**SHADY SHORES TOWN COUNCIL
SHADY SHORES PLANNING AND ZONING COMMISSION
SPECIAL CALLED JOINT MEETING
DECEMBER 6, 2022; 6:30 PM
101 S.SHADY SHORES ROAD
SHADY SHORES, TX 76208**

Re: Plat Approval Request for Lots 1-5, Block A Herd Addition
Town of Shady Shores
Project No. 0160012012

TOWN ENGINEER
Comments
11-29-2022
Revise and Resubmit

TITLE: *POST-DEVELOPMENT
DRAINAGE AREA MAP*

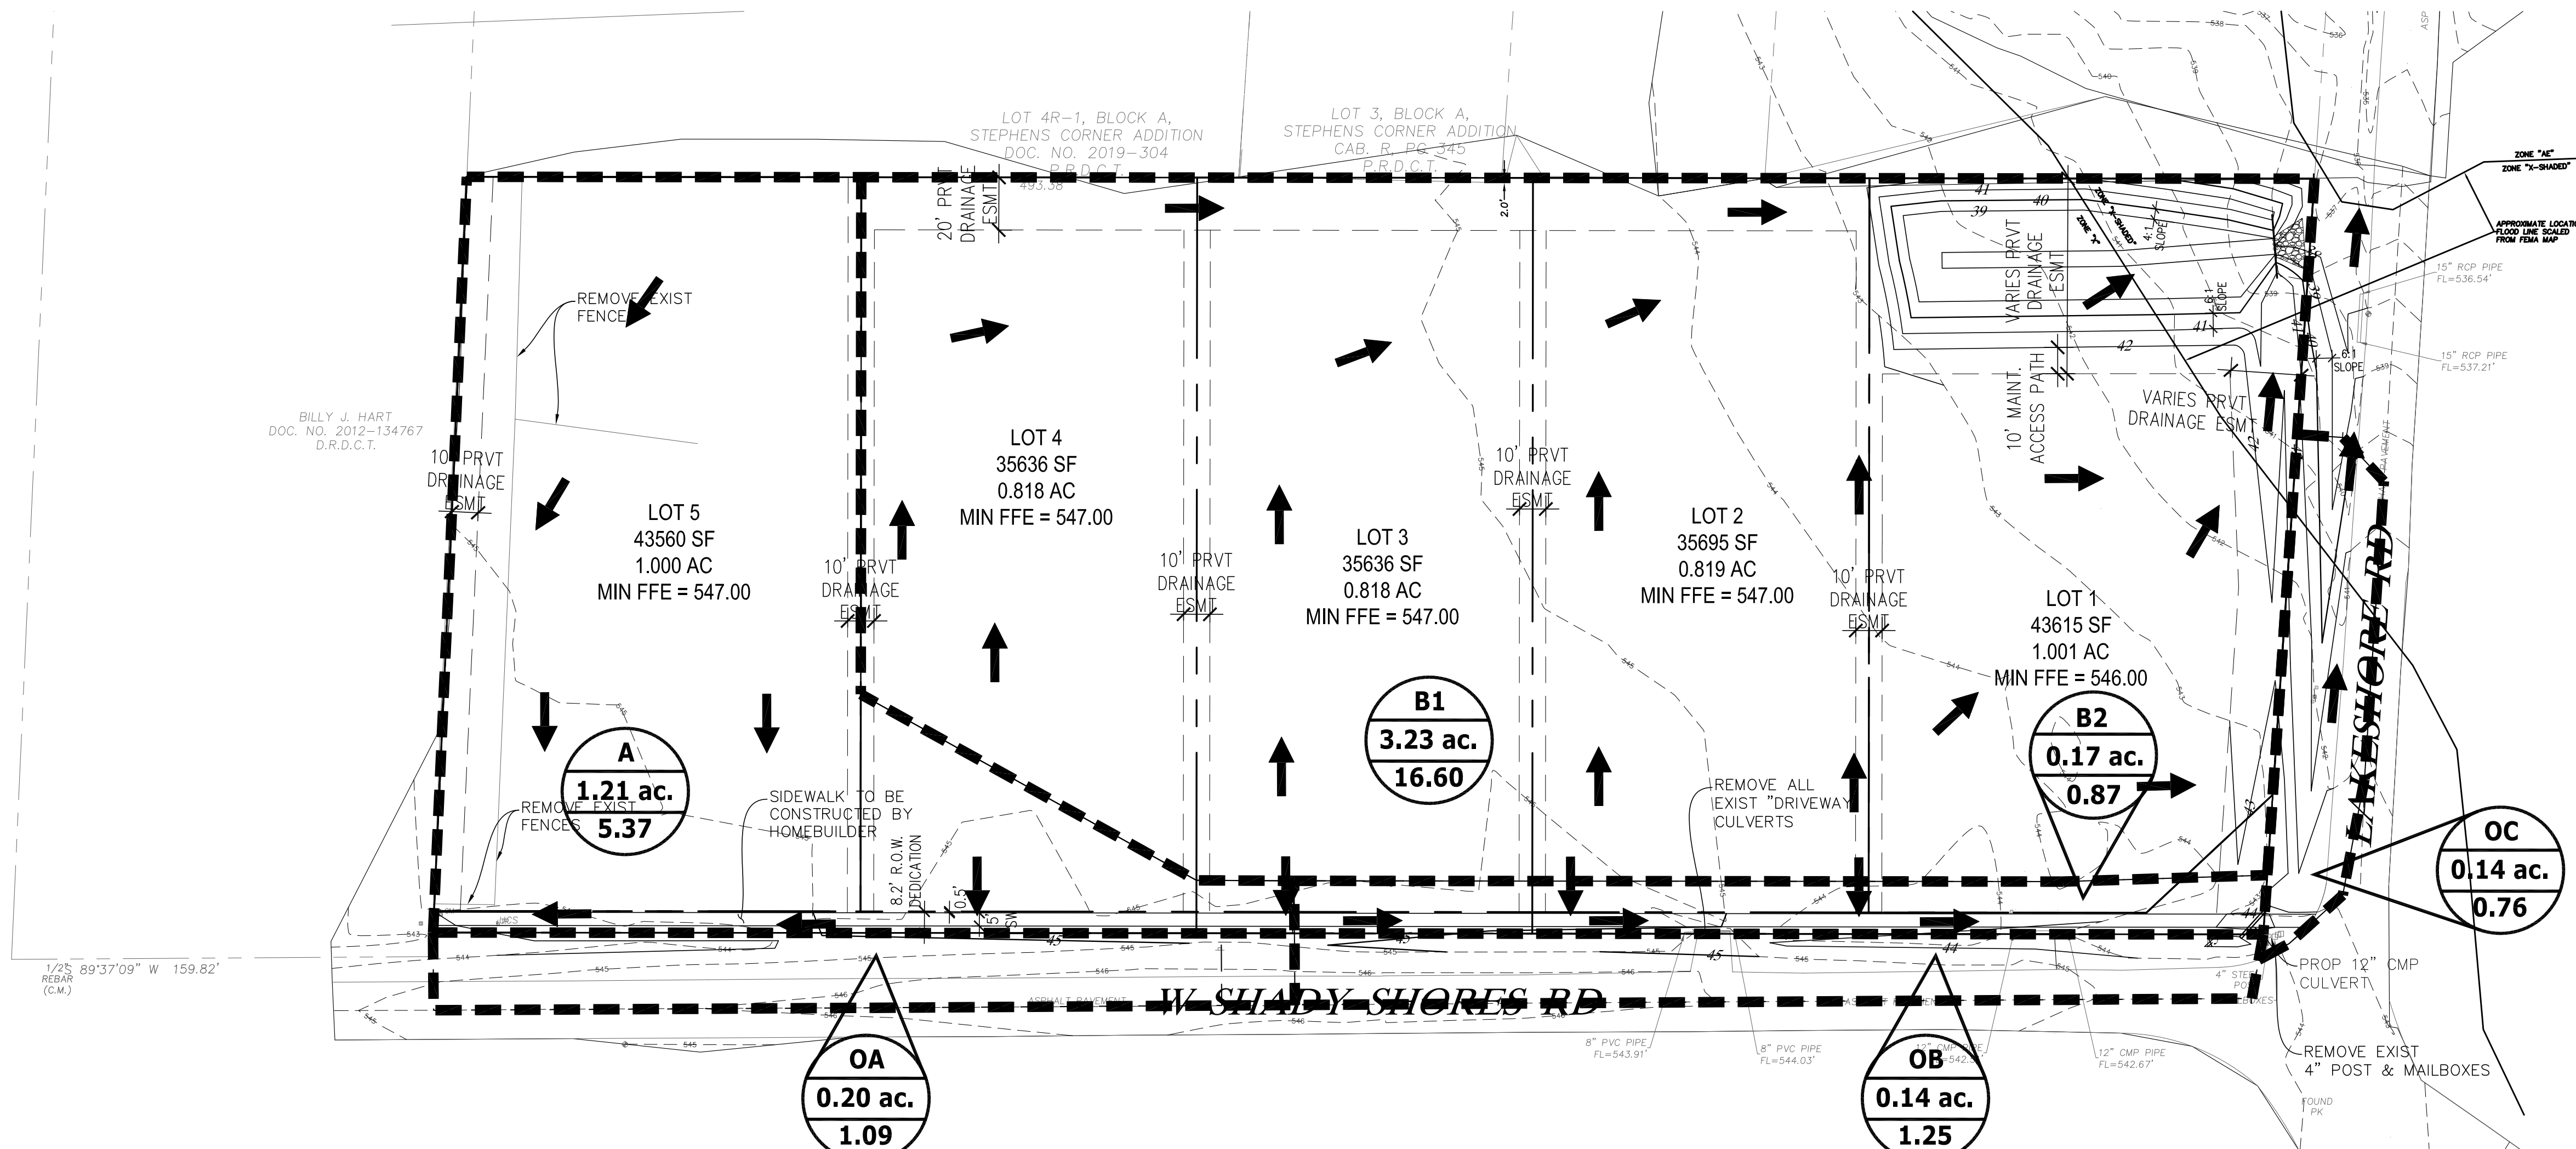
- 1. The applicant submits for review and approval revised drainage sheets and associated calculations that are based off the Town's drainage criteria listed in our comments noted on the construction plan mark-ups. These include revised time of concentration for existing conditions and revised runoff factors for existing and proposed conditions.***

SHEET TITLE: **DETENTION POND PLAN**

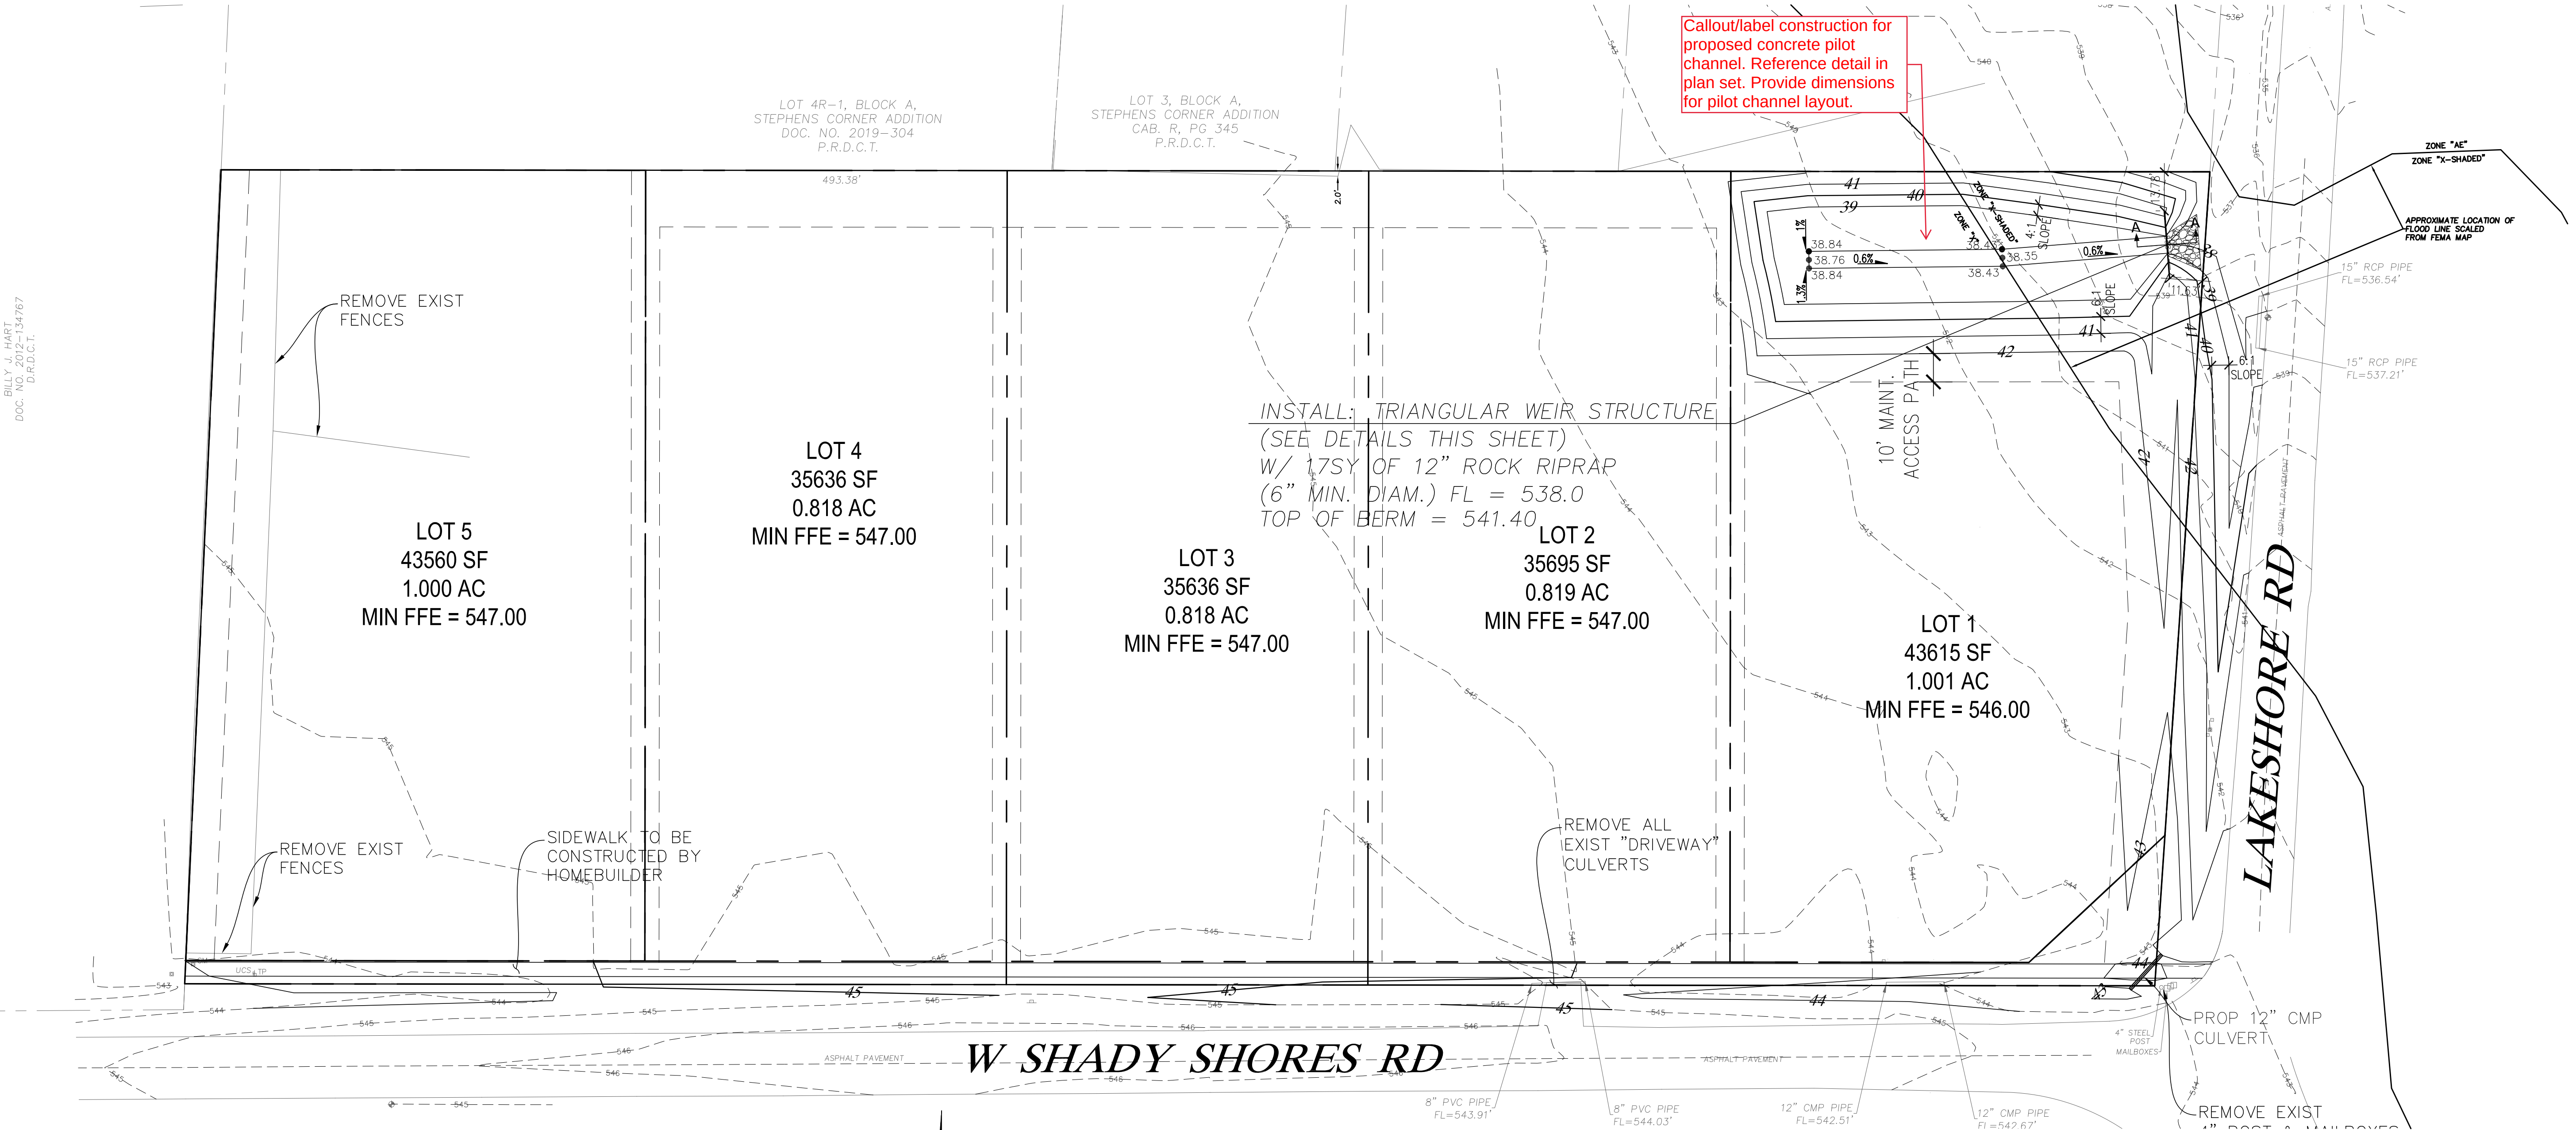
- 2. The applicant submits for review and approval revised construction plans that incorporate a 6-foot-wide concrete pilot channel in the private detention pond per ordinance and side slopes within the detention pond that provide for positive drainage to the pilot channel as noted.***

- 3. The applicant provides revised construction plans and final plat reflecting any changes to the private drainage easement that contains the proposed detention pond, as may be necessary in satisfying the requirements of the items listed above.***

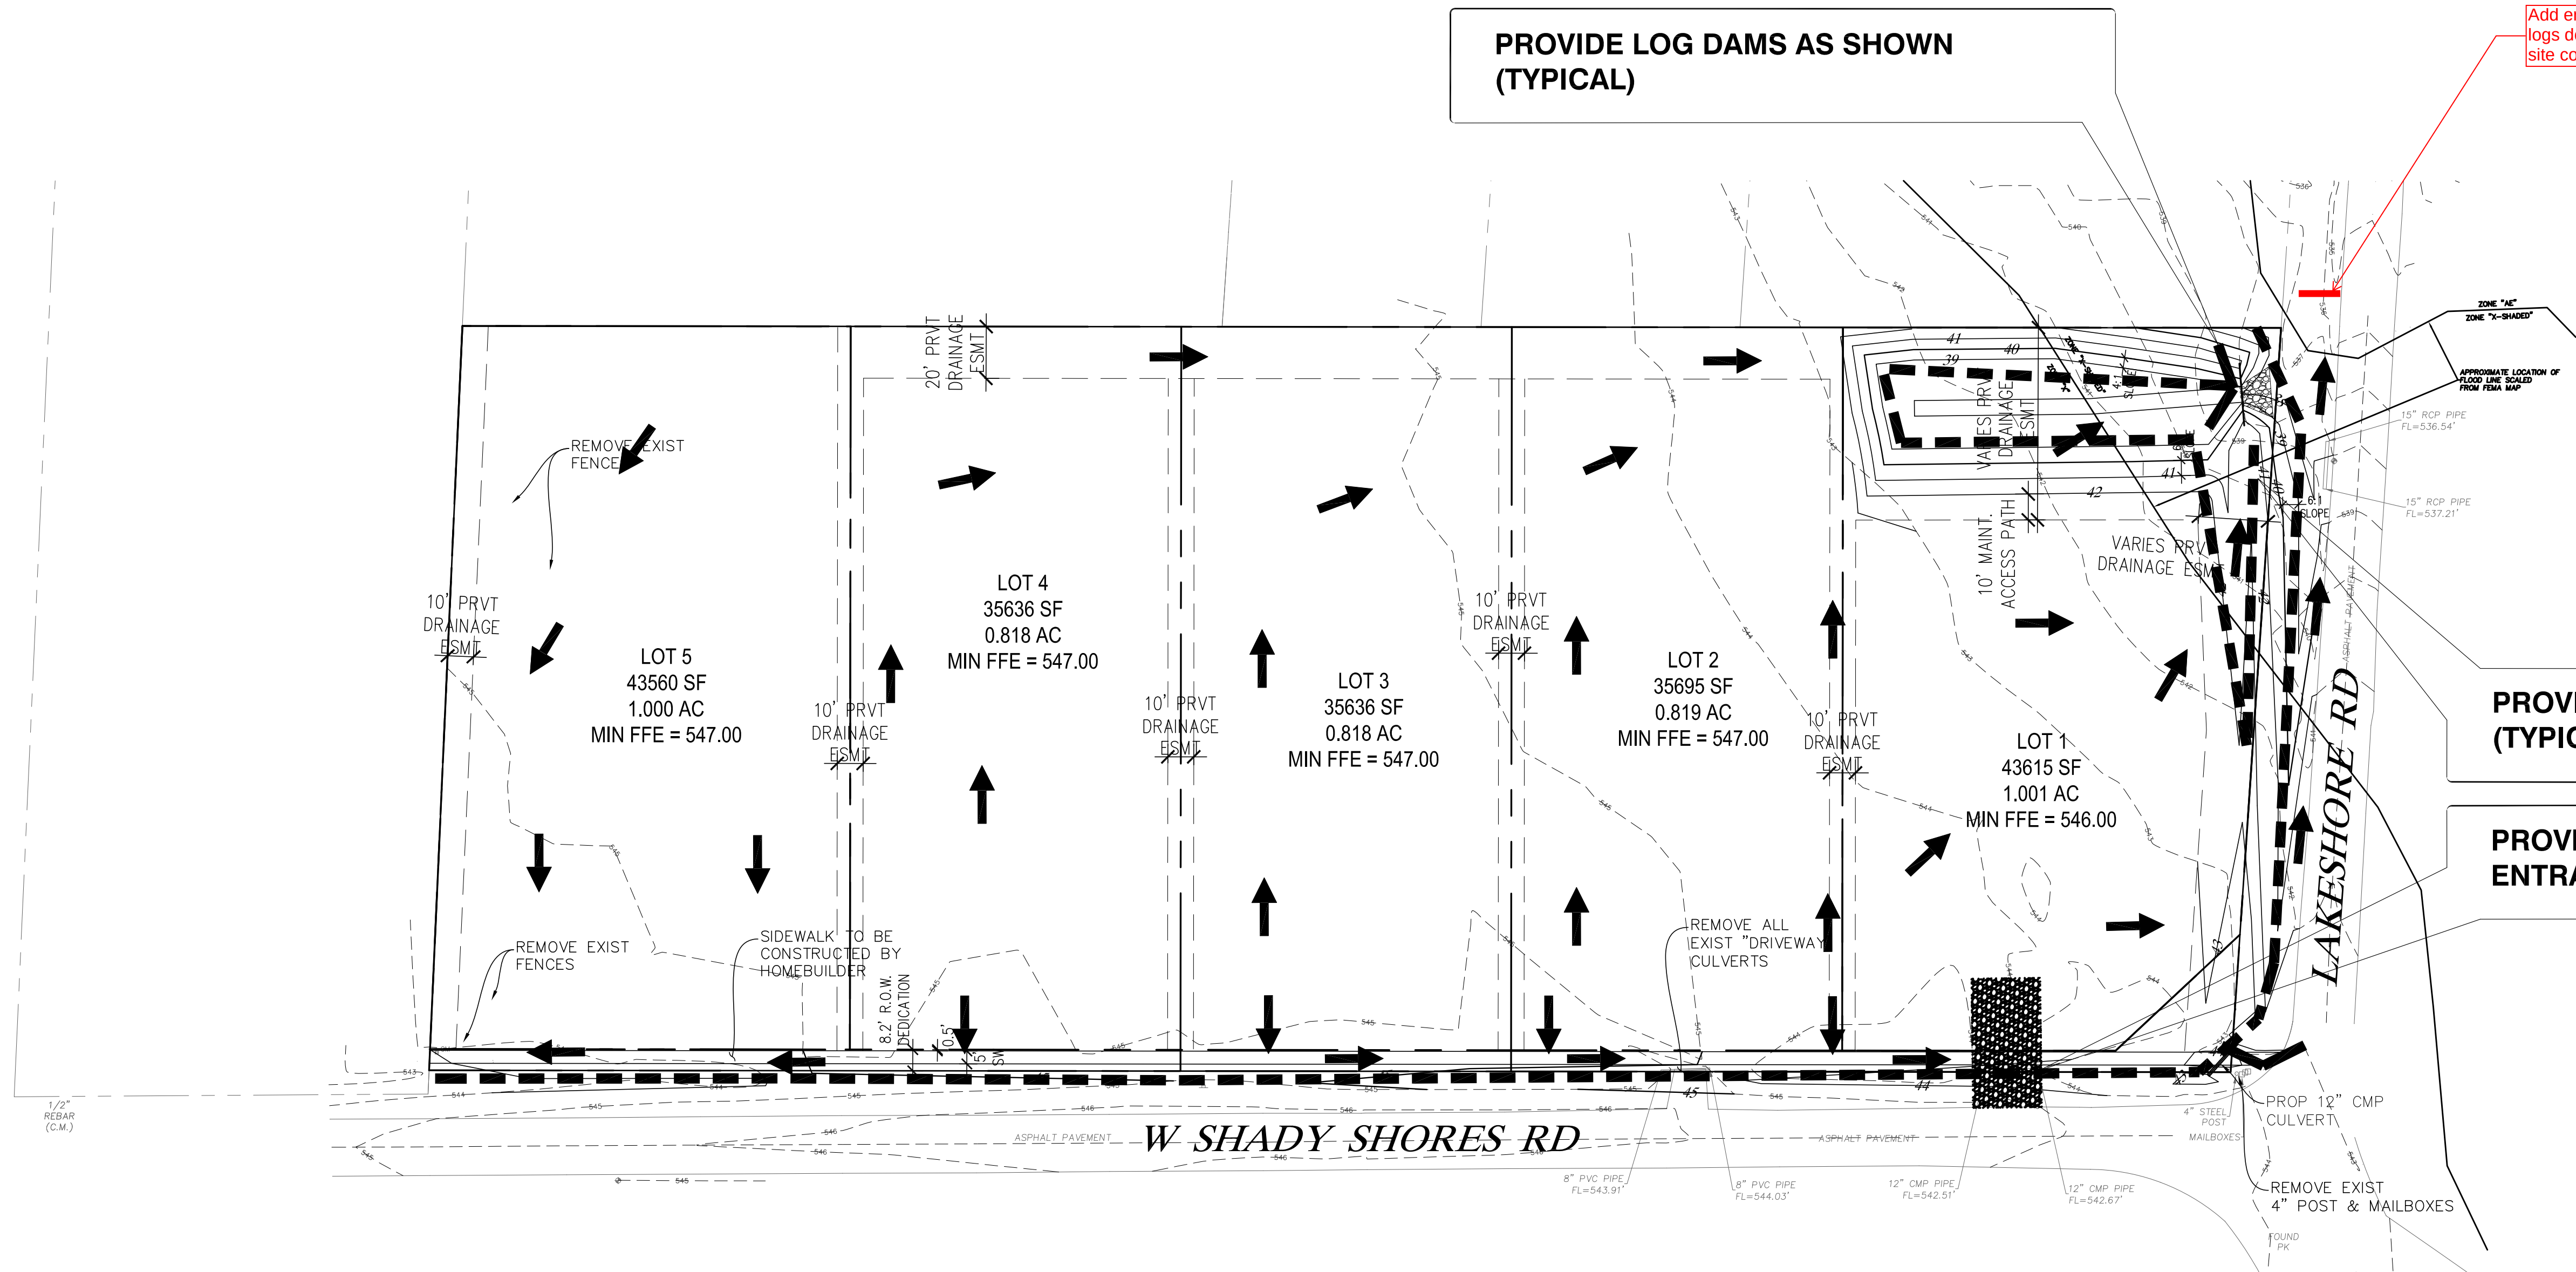
Add erosion control logs downstream of site construction

Revise symbol for e.c. log to better differentiate from silt fence linestyle.
